# **HERON LAKES SUBDIVISION, PHASE TWO,** **CORRECTED PLAT, RESUBDIVISION OF AND** **ADDITION TO LOT 123**

APPLICATION NUMBER 22 DATE April 21, 2005

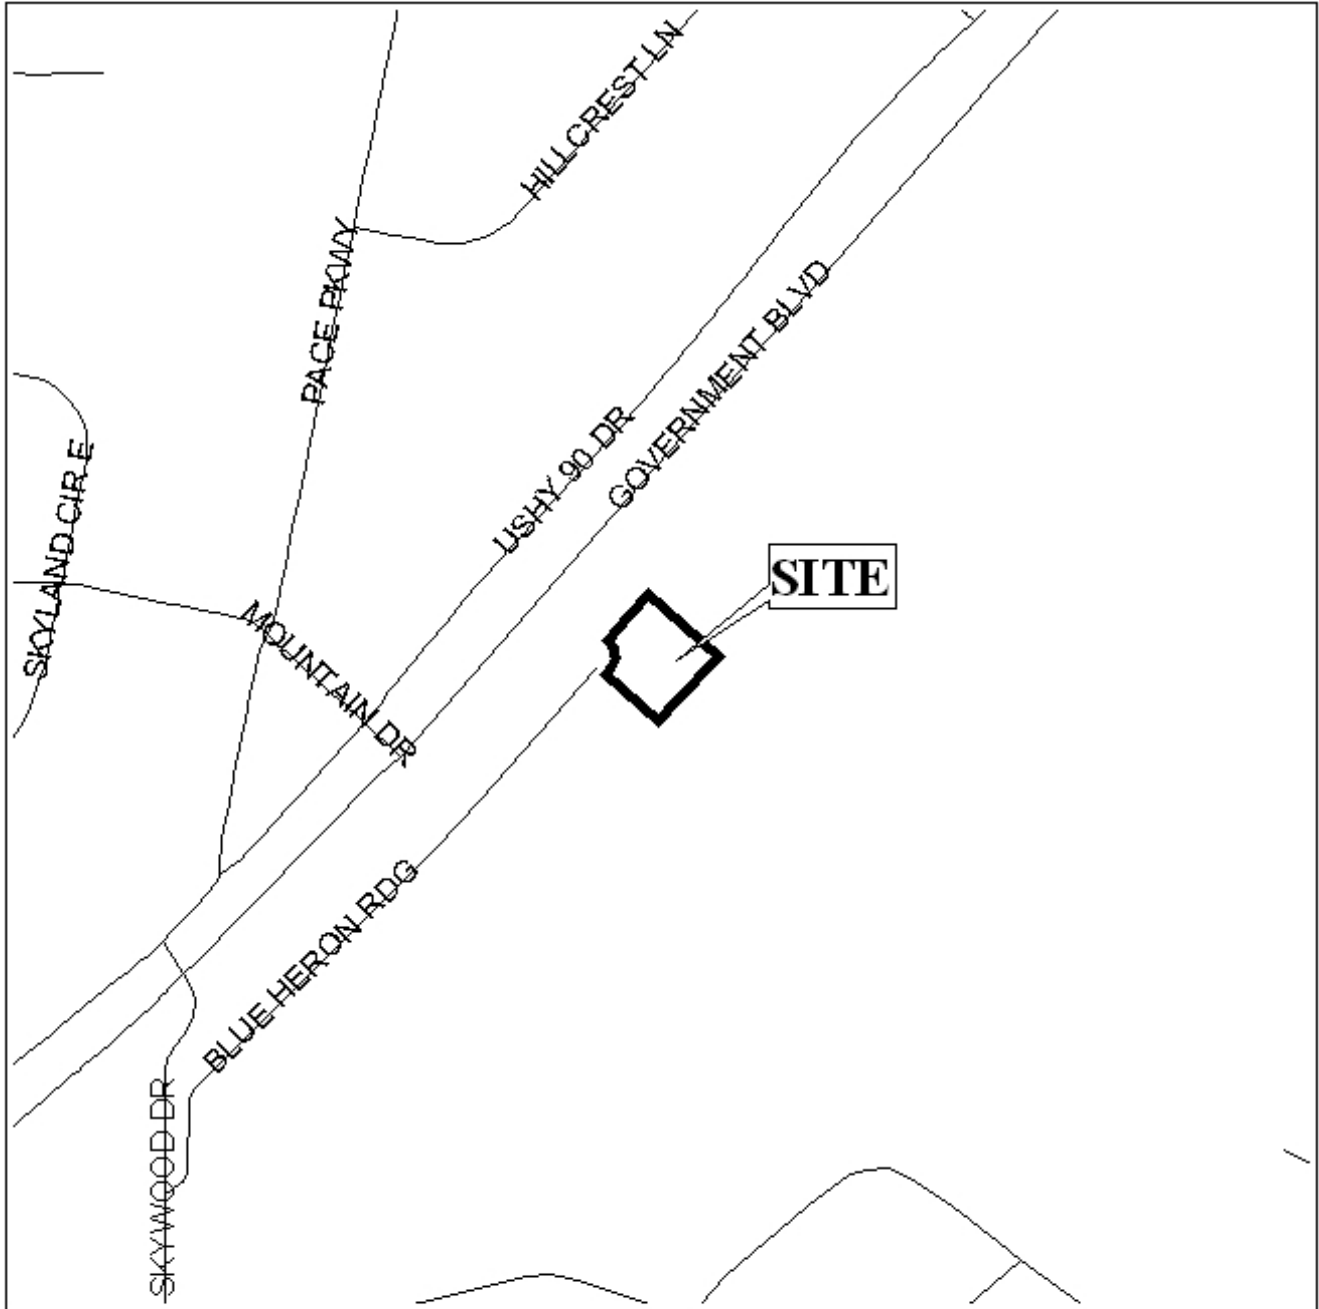
The proposed lot 3's depth to width ratio is approximately 4.7 (depth is 4.7 times the width of the lot at the minimum building setback line), which is greater than the 3.5 recommended in Section V.D.3. of the Subdivision Regulations. Lot 3's high depth to width ratio is due to the lot being flag-shaped in order to provide maximum frontage onto the existing golf course. Due to an existing building east of the proposed lot 3, options to reconfigure the lot are somewhat limited. Therefore, a waiver of Section V.D.3. could be considered appropriate.

Finally, three of the bearings illustrated on the plat conflict with the written description. The bearings on the plat should correspond with the written description on the Final Plat.

Based upon the proceeding, the plat is recommended for Holdover for the following reasons: 1) the proposed subdivision will require the amendment of an existing PUD, therefore the applicant must submit an application to amend the existing Planned Unit Development so that the subdivision and PUD applications may be reviewed concurrently; 2) the submission of a revised plat to include all parcels that are part of the subdivision request, as well as any additional property-owner notification information; and 3) the correction of the directional bearings to agree with the written description of the site boundaries.
